**ALTERNATE #2
RESOLUTION NO. 14-07**

RESOLUTION OF THE TOWN OF ST. LEO TOWN COMMISSION
APPROVING SPR/VAR #14-A, THE SAINT LEO UNIVERSITY PLANT
OPERATIONS FACILITY WITH CONDITIONS.

**SITE/LANDSCAPE PLAN REVIEW (SPR) STAFF REPORT
SPR/VAR#14-A: Saint Leo University Plant Operations Project
Town Commission Meeting August 11, 2014**

EXHIBIT C
Proposed Landscape/Open Fence Buffer

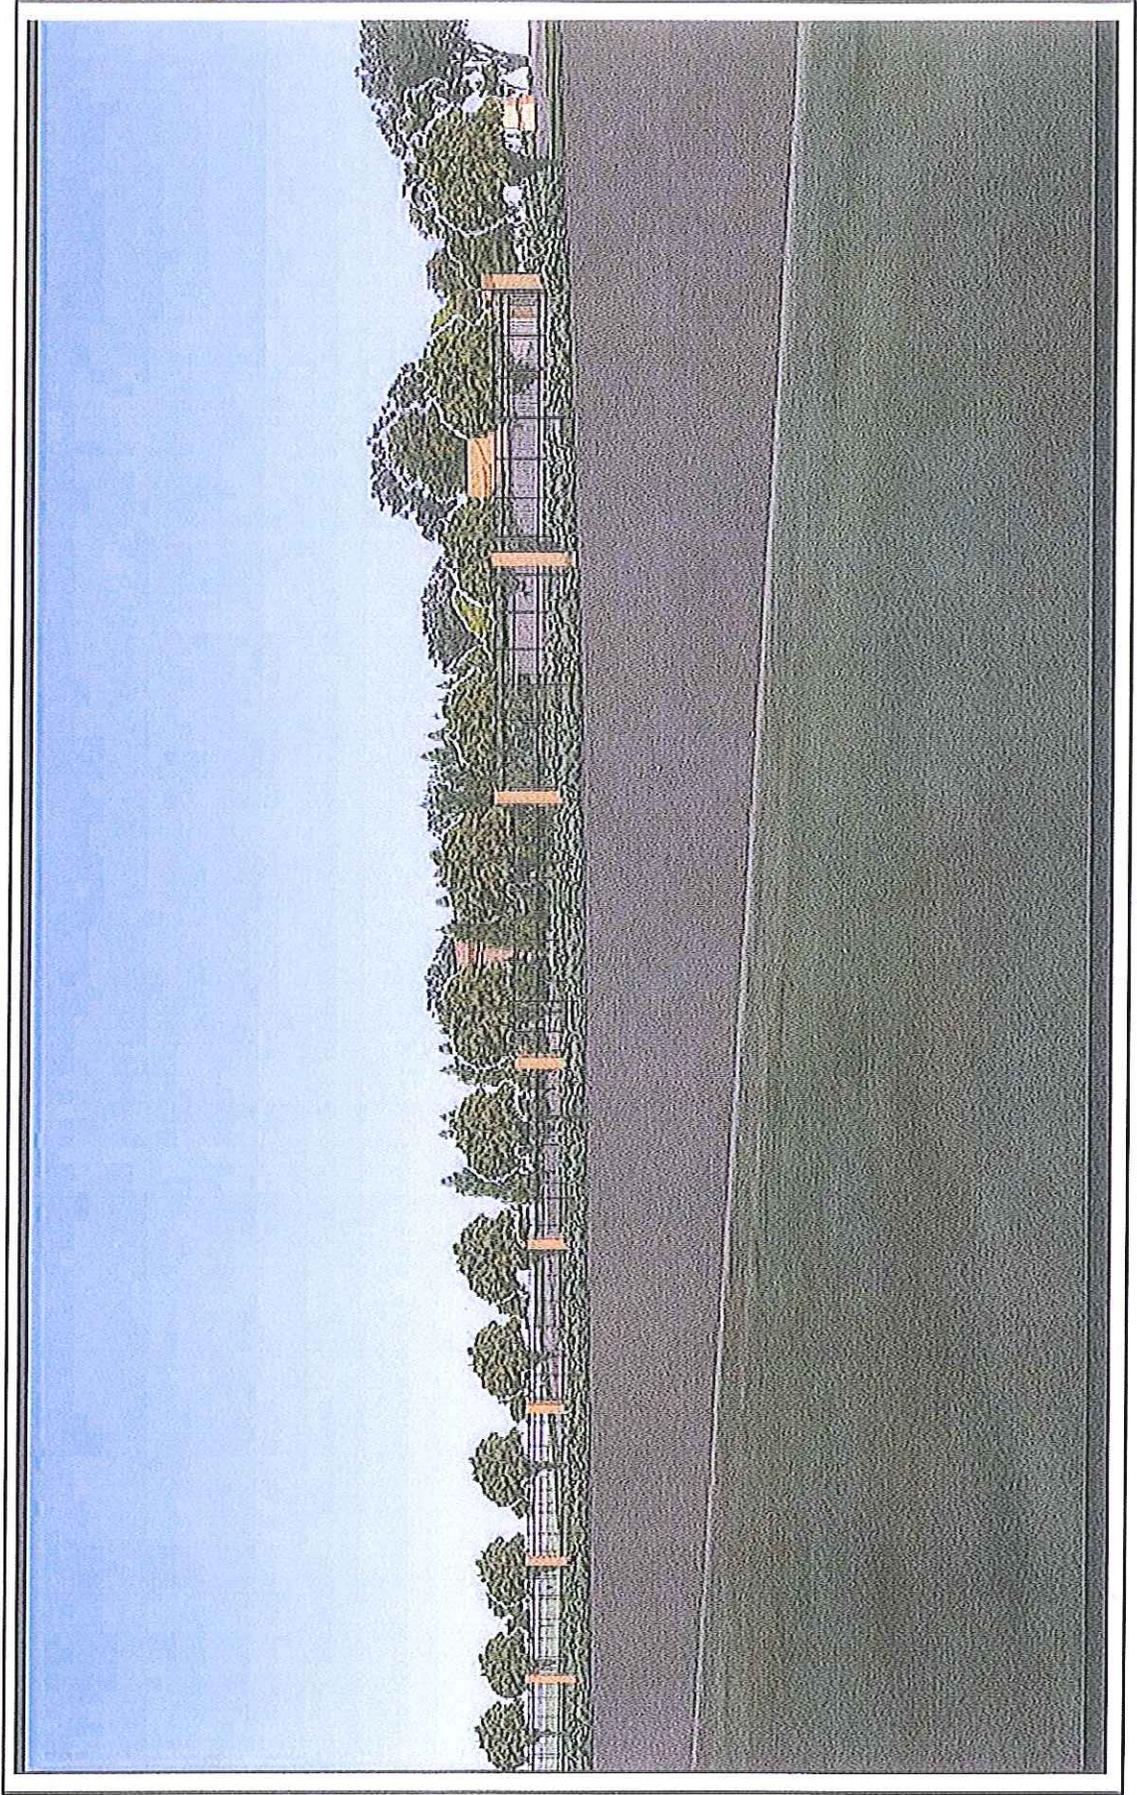
The Applicant is requesting a variance not to provide the solid decorative fence or wall, but construct a wrought-iron style open fence (Exhibit C). The justification provided by the Applicant does not have merit. The site is a plant operations facility use, which will have truck deliveries on a daily basis. The abutting property is designated Low Density Residential, although currently vacant; dictates a solid fence or wall should be required to mitigate potential visual, lighting and noise impacts.

7. Provide the required solid fence or wall along McMullen Drive to be approved by the Town Planner.
8. Any revisions to the attached Landscape Plan Alternative B shall be provided to the Town Planning Consultant for approval prior to the issuance of final building inspection of the project by the Town's Building Official. Any variances will require a public hearing pursuant to Article IX.

EXHIBIT D
Landscape Plan

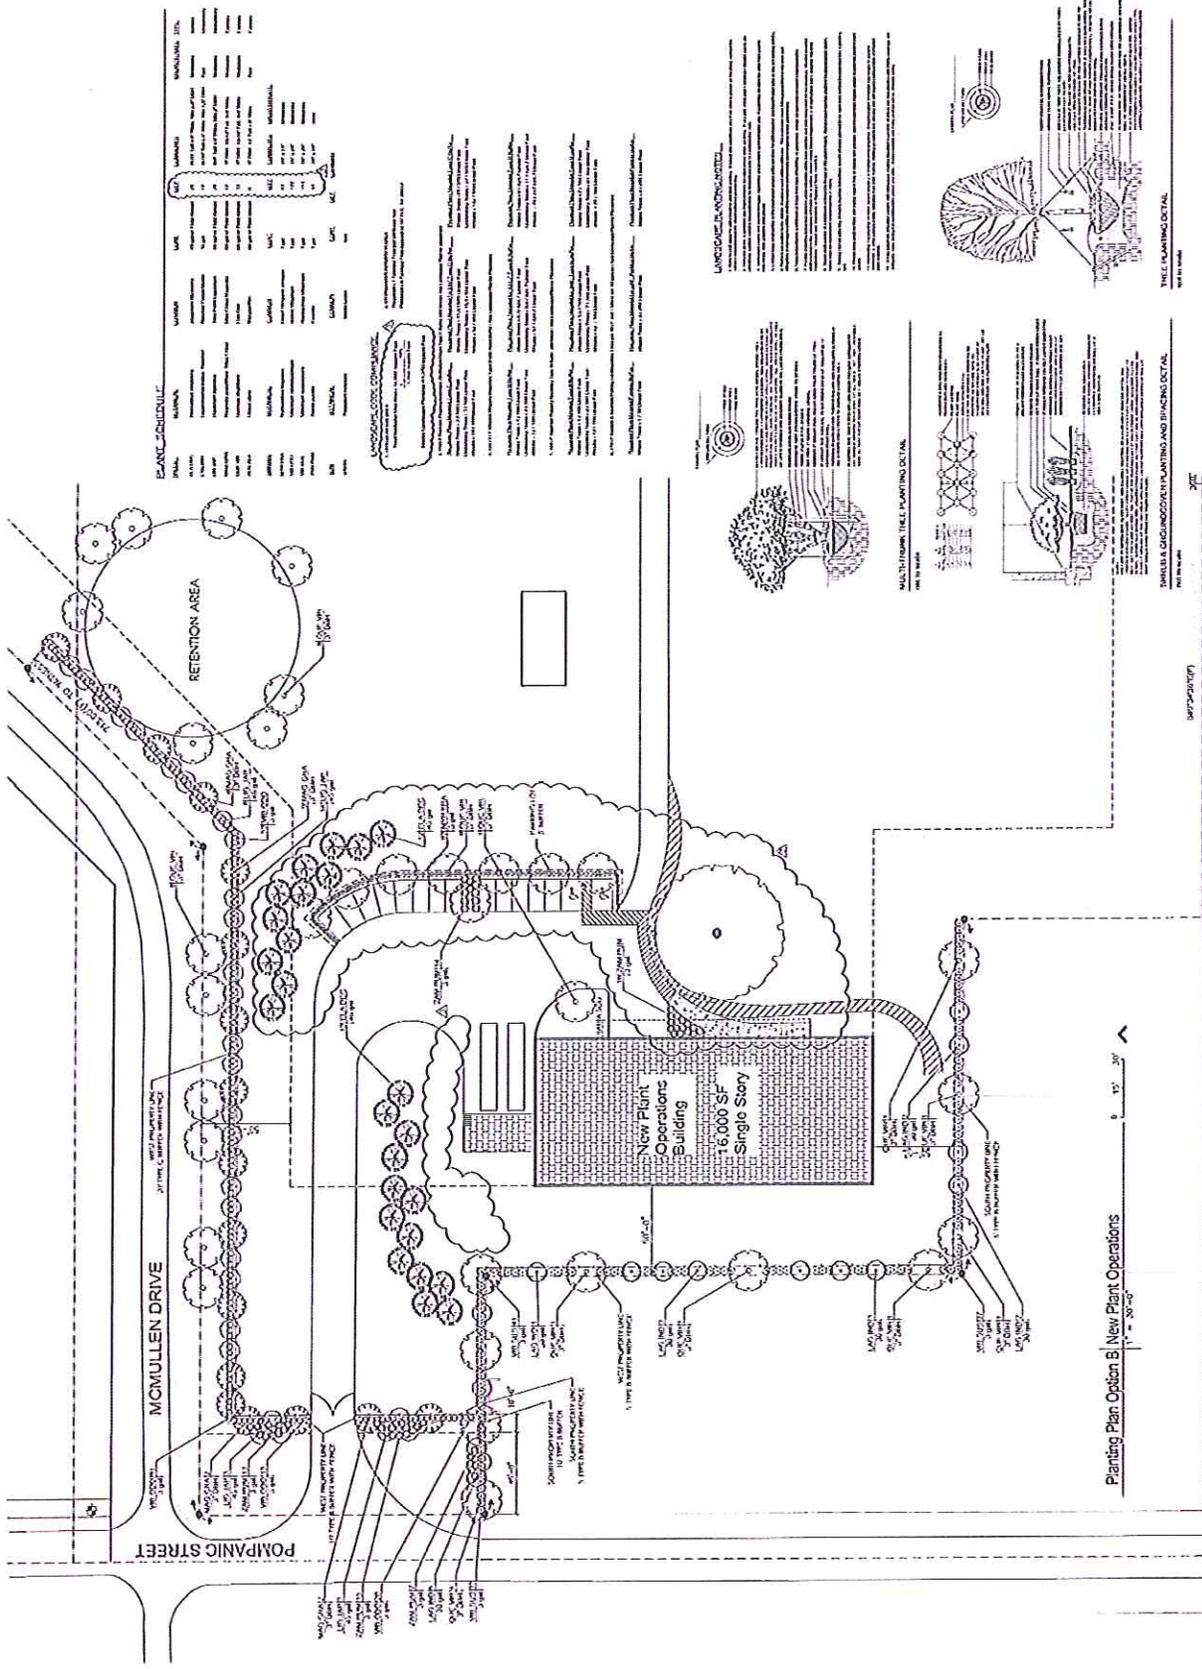
The Applicant is requesting a variance not to provide the solid decorative fence or wall, but provide an open design wrought style fence (Exhibit C). It is noted that the University is complying with the Type "C" landscaping requirements (Exhibit D).

8. Any revisions to the attached Landscape Plan Alternative B shall be provided to the Town Planning Consultant for approval prior to the issuance of final building inspection of the project by the Town's Building Official. Any variances will require a public hearing pursuant to Article IX.
